## **Street Audit: Tollcross (Edinburgh)**

**Living Streets Edinburgh Group**

**October 2015**

Figure 2

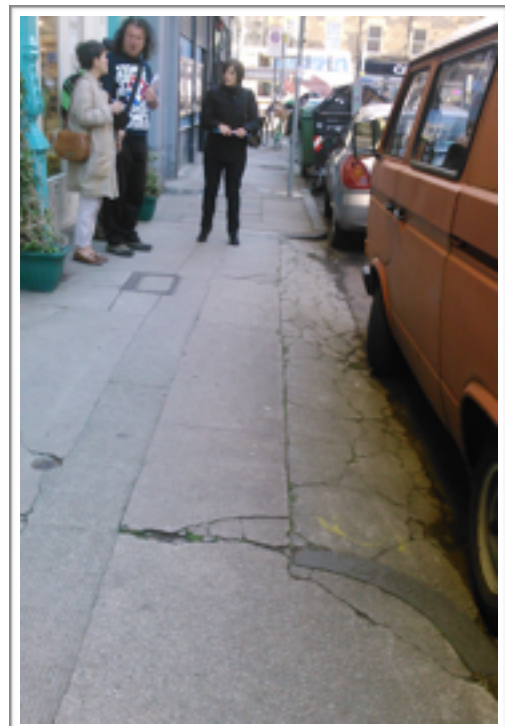
It was noted that some sections of the footway on Lochrin Place (North side) retain vestiges of old kerbs, presumably remnants from former vennels (Figure 2). These should be retained, in order to maintain some elements of the historic streetscape.
